PUN 2018F

Product Update Notice

Units Affected: LRV-60E70 and LRV-60E70RM Units

LR Elevator Slope Ratings

Figure 1 — Slope Indicator

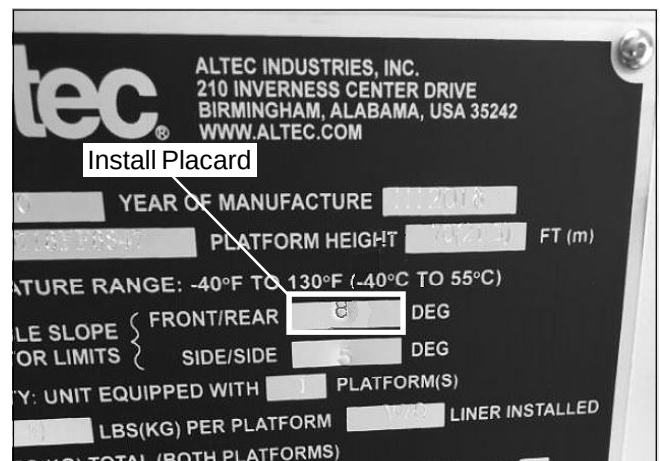
Altec LR760E70 and LRV60E70 aerial devices currently meet the applicable standards for stability when the unit is set up on slopes of up to 5 degrees side to side. The units also meet current stability standards when set up with the chassis on a front-to-rear slope of up to 8 degrees. Altec has discontinued the previously allowable front-to-rear setup on slopes between 5 and 8 degrees based on customer feedback and to increase the margins of stability. Beginning with September 2018 production, the slope indicators and serial number plates are labeled to limit the allowable front to-rear-slope to 5 degrees.

Altec is offering kits to owners of older units who want to update the unit to operate with the increased margin of stability as on the new LR760E70 units. The kit consists of small placards to be installed on the unit to show the new standard. Each unit requires up to three of the new placards. One placard will be installed on each front-to-rear slope indicator (refer to Figure 1). There are one or two front-to-rear slope indicators depending on the unit. Another placard will be installed on the serial number placard (refer to Figure 2).

Figure 3 — Placard Strip

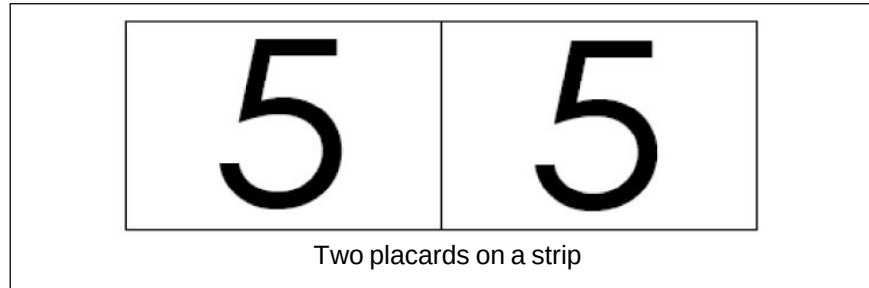
Kits are available for single units (refer to Figure 3) or for customers who own a larger quantity of units. Order the update kit from the list below by calling 1-877-GO-ALTEC (1-877-462-5832).
